Access Compliance Report Public Rights-of-Way (Pedestrian Signals)

Main Street: CERRITOS_AVE Cross Street: GILBERT_ST Location: NE

ADA ID: SGRK210923130910 Signal Type: One Push Button-Non APS Overall Compliance: No Severity Scores: BTN 1: 25 BTN 2: N/A No BTN: N/A

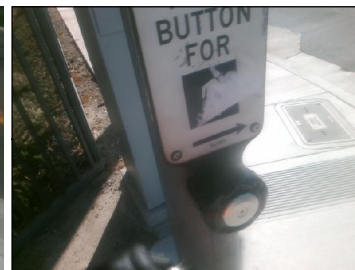
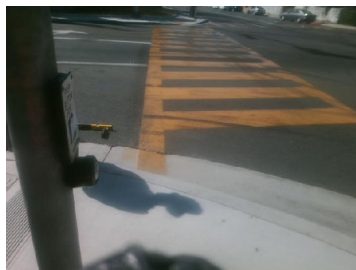
OC Std/PROW: R404.2, R404.3

Possible Solutions: Remove and Replace Clear Space.
